DESIGNED: MAB DRAWN: HIG CHECKED: MAB DATE: 11/26/18	REVISION
RESPEC 3520 AUSTIN BLUFFS PARKWAY SUITE 102 COLORADO SPRINGS, CO 80918 PHONE (719) 266-5212	
<p>Know what's below. Call before you dig.</p> <p>PROJ NO. 03524          DWG NM. 03524-Dev-Fil2</p>	Guman & Associates, LLC 731 N Weber St, Suite 10 COLORADO SPRINGS, CO. 80903
ROADWAY PLAN OVERALL	GLENEAGLE SUBDIVISION, FIL #2
DRAWING NUMBER: <b>C</b>	SHEET 1

GLENEAGLE SUBDIVISION, FIL #2

STONE EAGLE PL PLAN AND PROFILE

**Standard Notes for El Paso County Construction Plans**

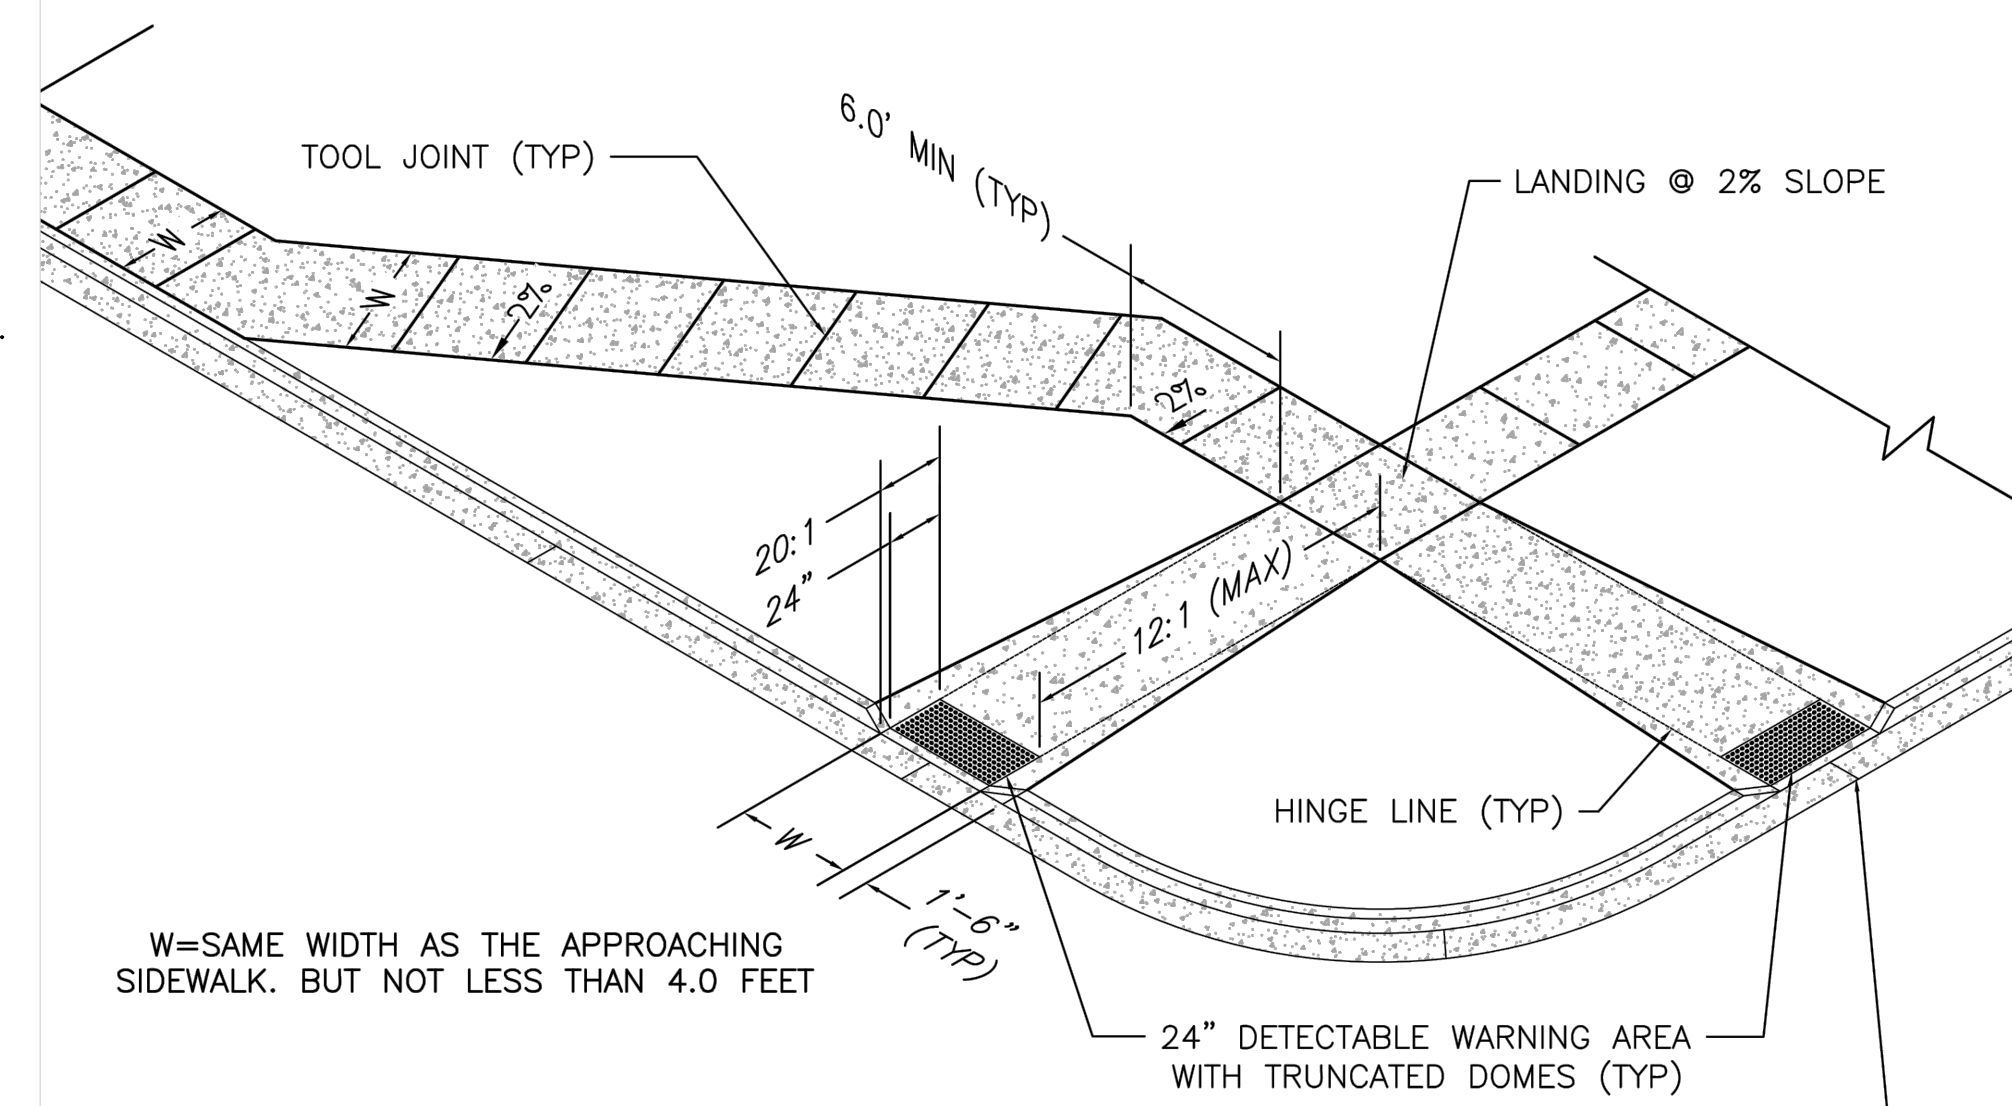
**Change to Planning and Community Development PCD throughout notes.**
- CONTRACTOR SHALL SCHEDULE A PRE-CONSTRUCTION MEETING WITH EL PASO COUNTY DEVELOPMENT SERVICES DEPARTMENT (DSD) - INSPECTIONS, PRIOR TO STARTING CONSTRUCTION.

**TYPICAL STREET SECTION @ FILL**  
NOT TO SCALE

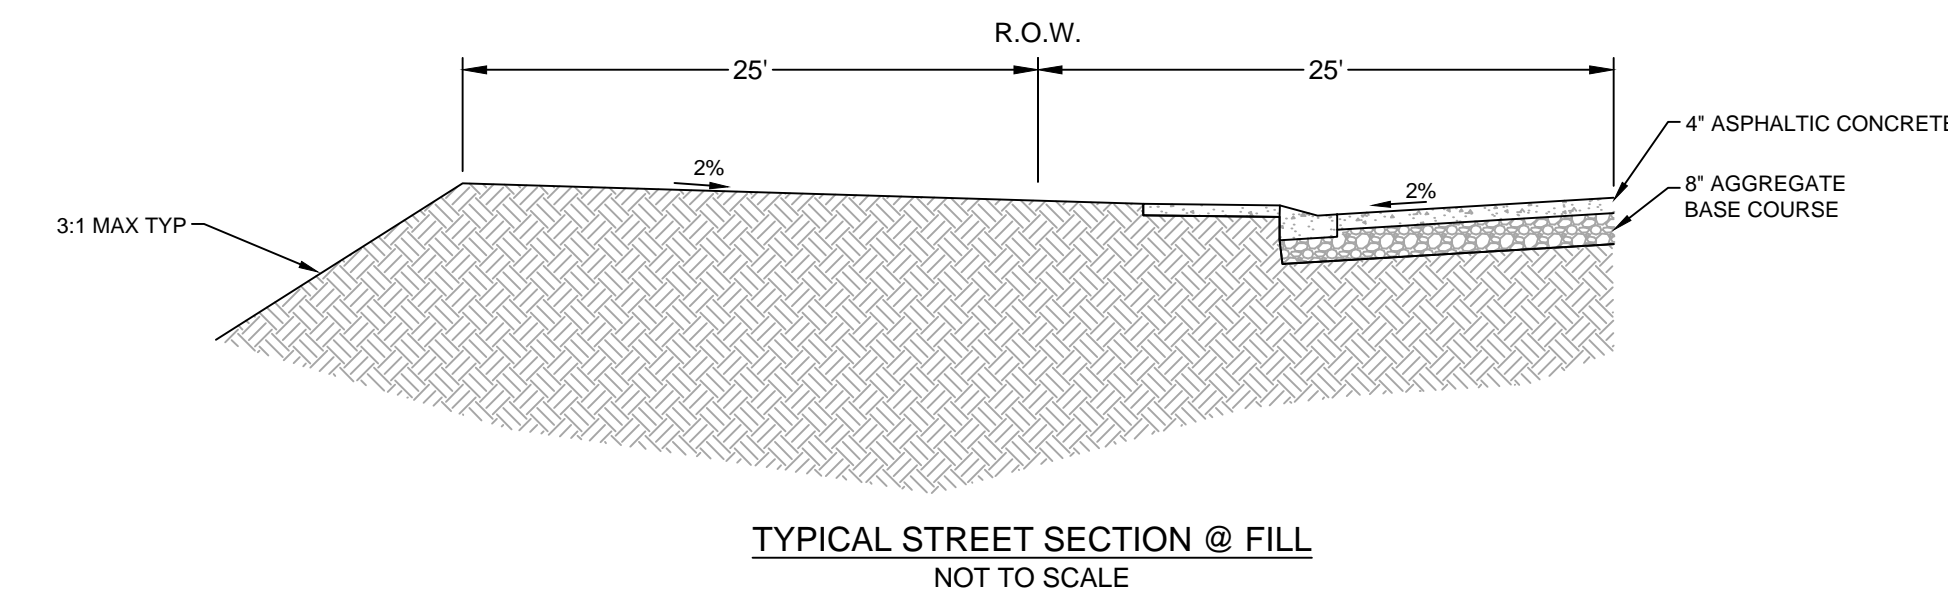
Call out: Asphalt pavement and aggregate base course subject to a pavement design review and approval by El Paso County.

Call out: Asphalt pavement and aggregate base course subject to a pavement design review and approval by El Paso County.(

**CURB OPENING WITH DRAINAGE CHASE DETAILS**  
NOT TO SCALE

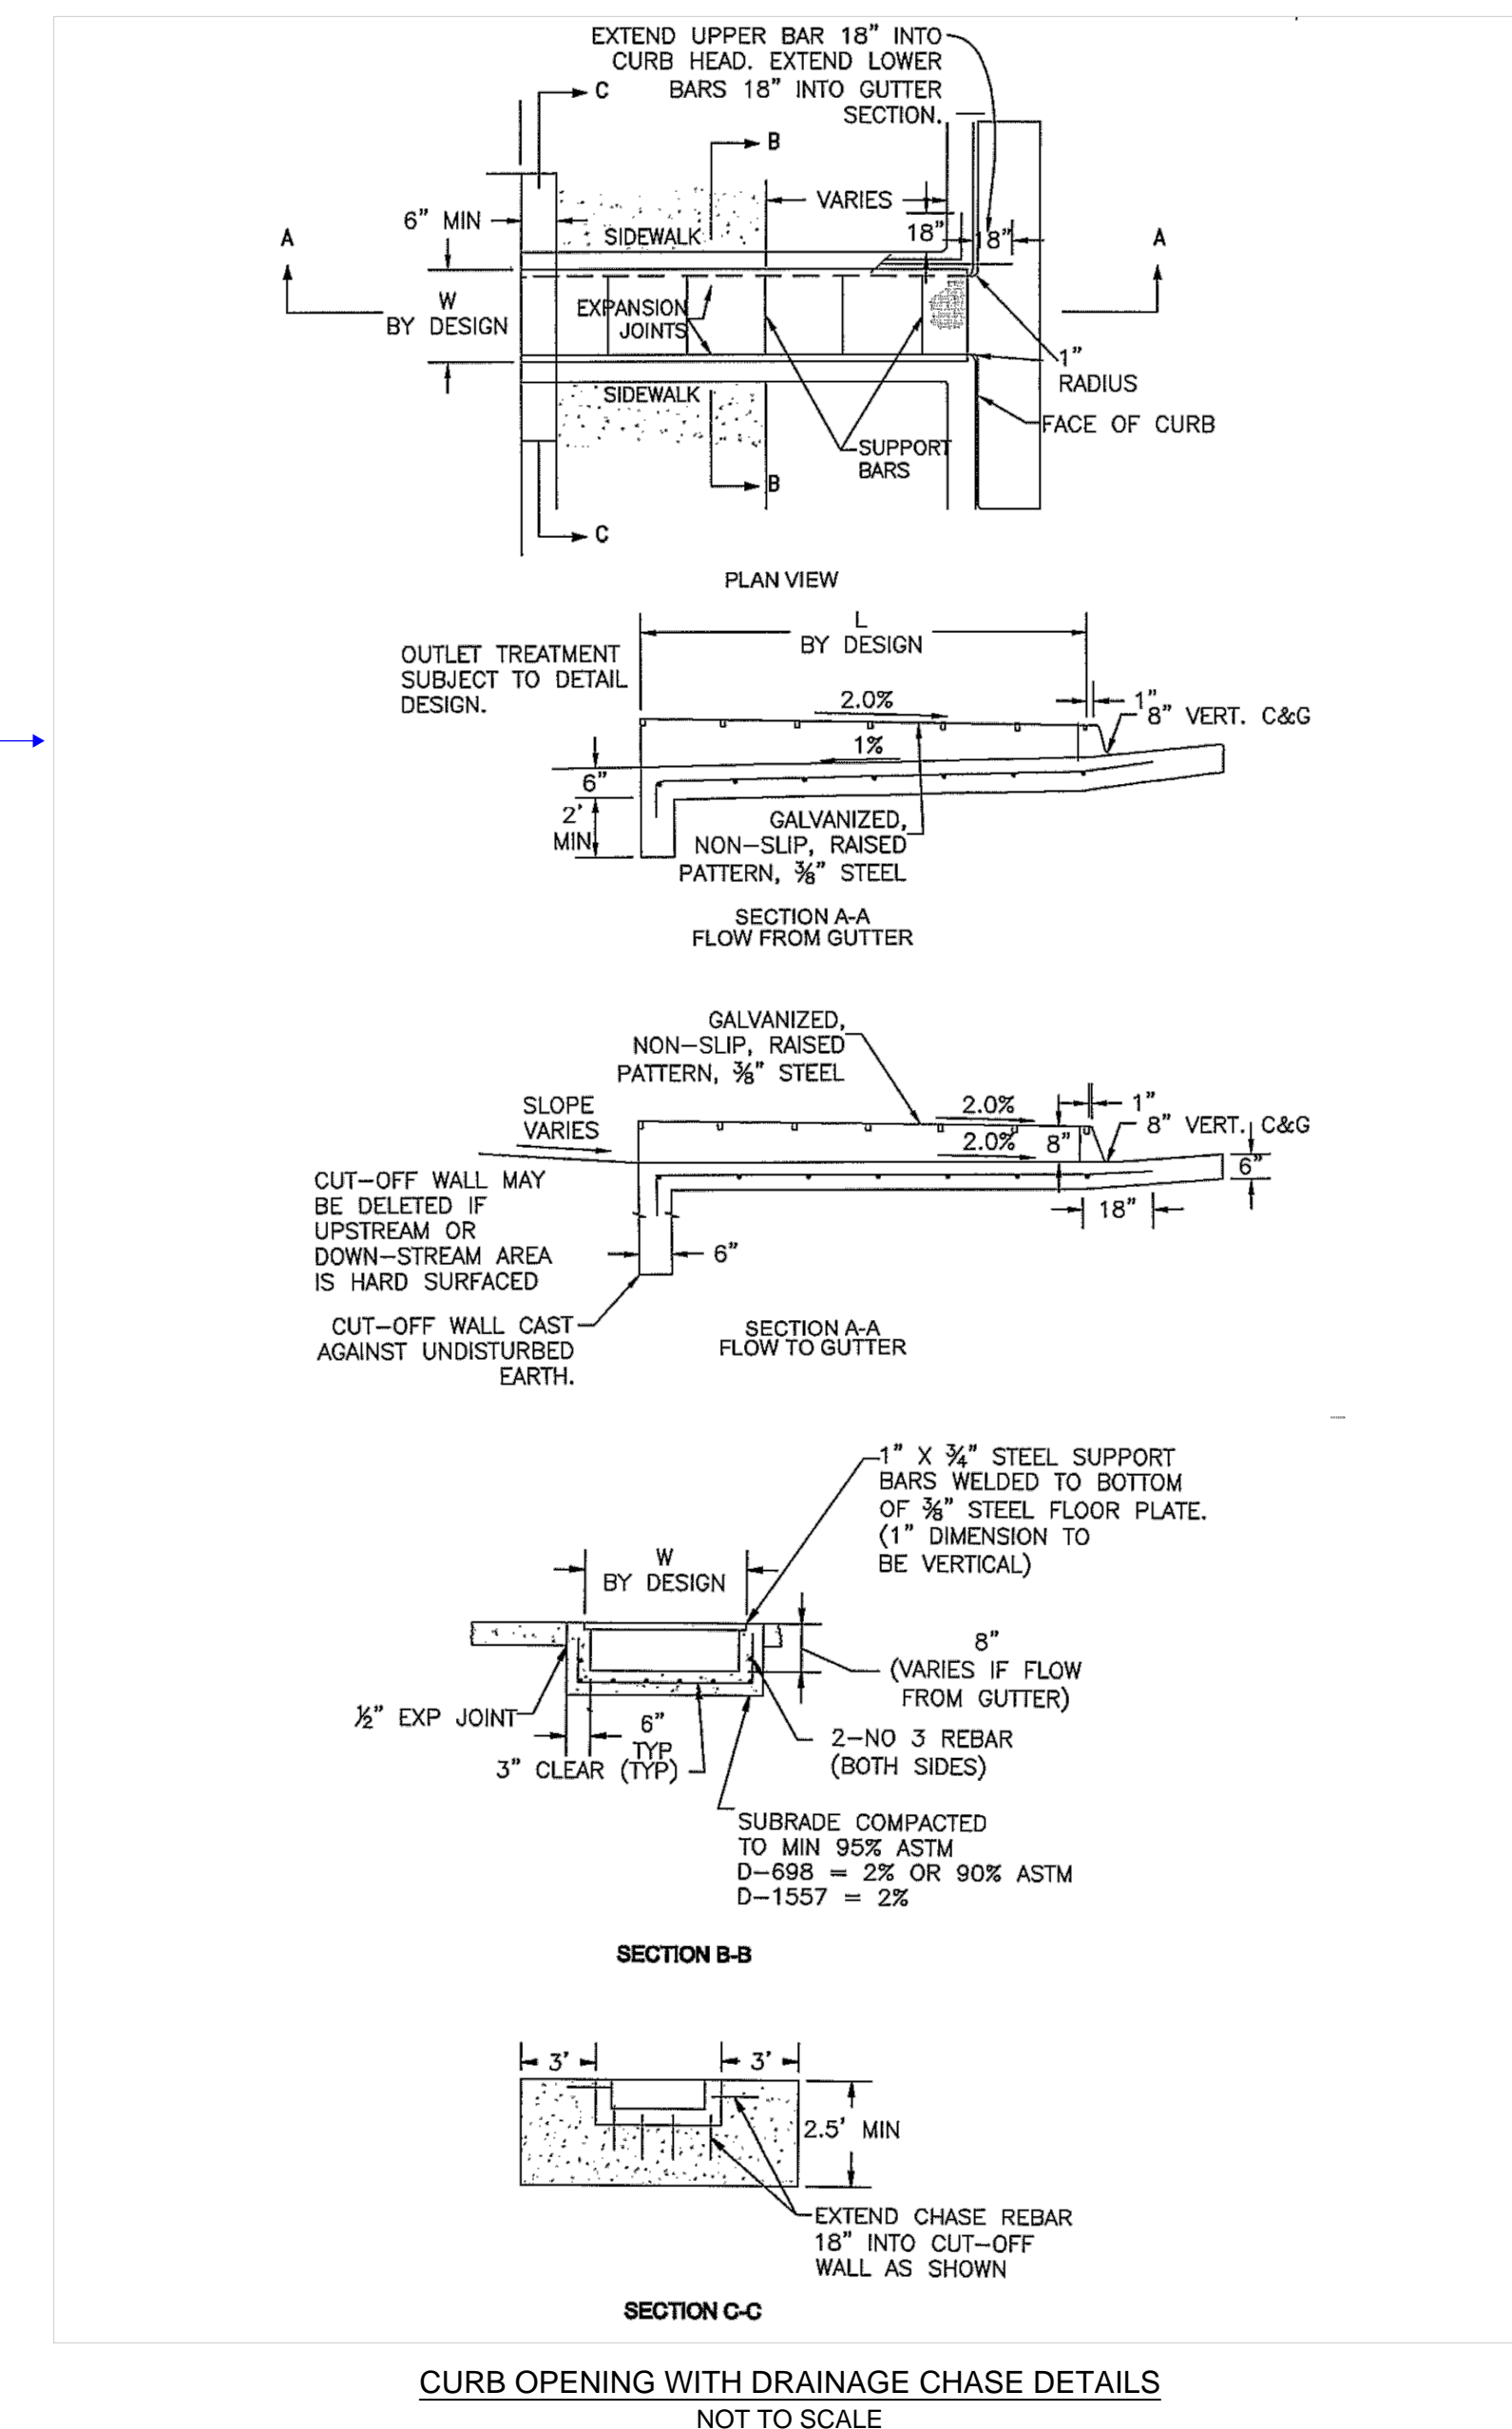
Revise to curb inlets.

Revise to curb inlets.
